**Petition for Post-Certification Amendment  
Hanford Energy Park Peaker  
CEC Docket No. 01-EP-7**

**Hanford Battery Energy Storage System  
115 kV Cable Interconnection Project**

**MRP San Joaquin Energy, LLC**

**March 4, 2022**

**FIGURE 2**  
**Trench Option**

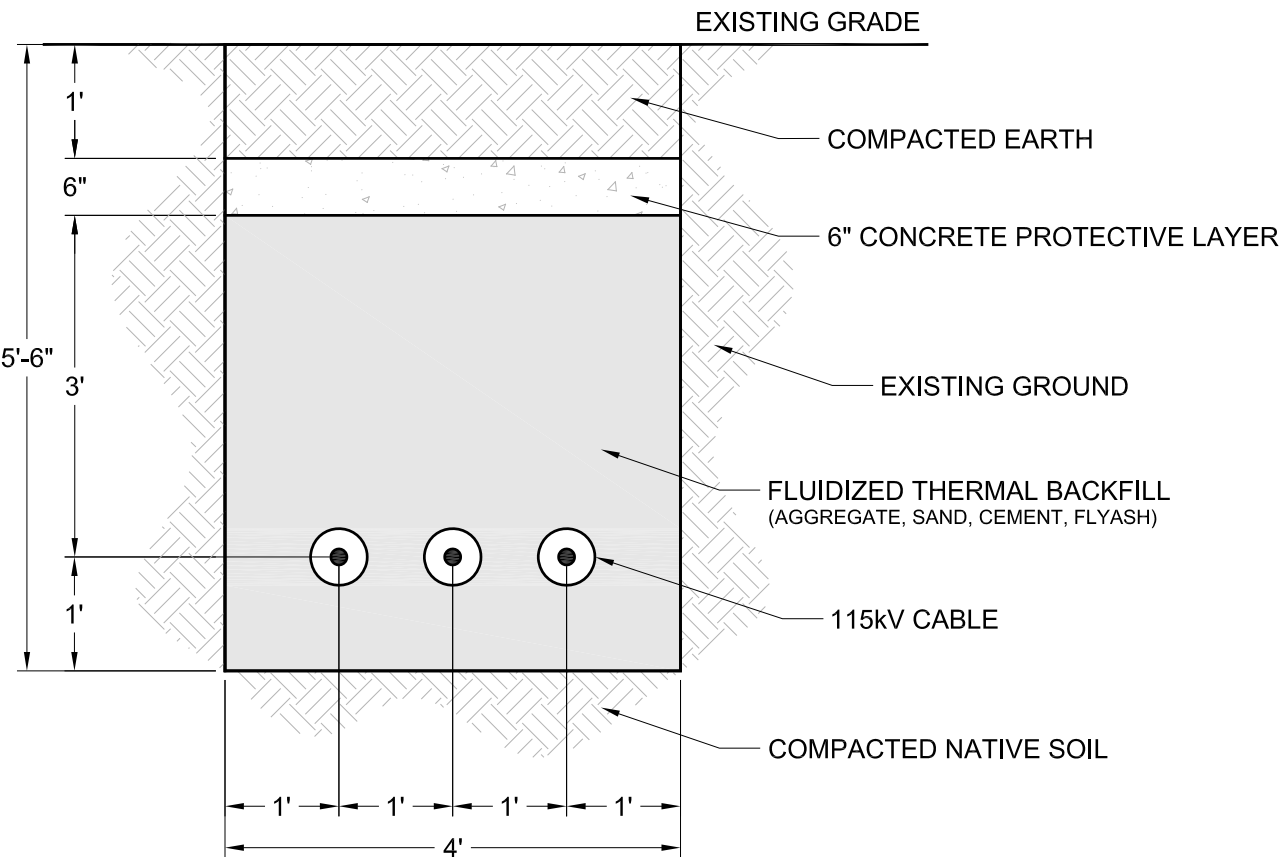
This option would involve trenching to place the 115 kV cable in PVC conduit in an underground duct bank (see cross section diagram on Figure 2 in Appendix A). The duct bank would be filled with Fluidized Thermal Backfill (FTB) designed to provide proper heat dissipation from the cable. A reinforced concrete slab would be placed on top of the FTB to provide protection to the cable. Select backfill would be placed on top of the protective concrete slab to bring the area to finished grade. The expected dimensions of the trench are up to approximately 4-feet wide by 5- to 6-feet deep and up to approximately 200 feet in length on the HEPP parcel. Under this option and assumed specifications, approximately 180 cubic yards of excavated material would need to be removed and disposed of offsite in an approved manner.
